DART SERVICE INSTRUCTION

AMEND THE FOLLOWING INSTALLATION DRAWING: D205-564 REV B

CANADIAN STC: SH96-42 US FAA STC: SR00571NY

SECTION A-A
TYPICAL CLAMPING DETAIL

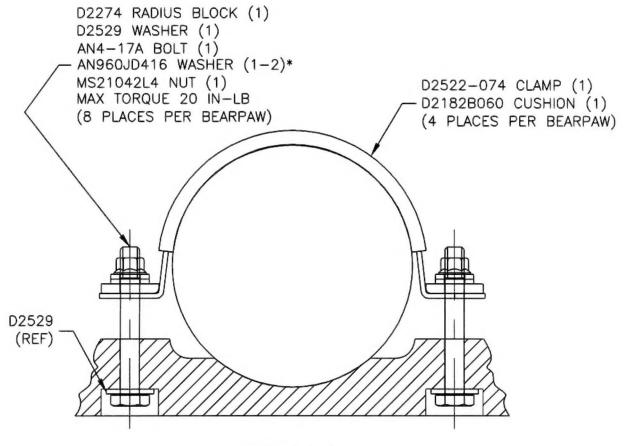
REPLACE D2522 CLAMP WITH D2522-074 CLAMP.
REPLACE AN4-13A BOLTS WITH AN4-17A BOLTS.
*ADDITIONAL AN960JD416 WASHERS MAY BE ADDED
UNDER NUT TO ENSURE 2-4 THREADS IN SAFETY
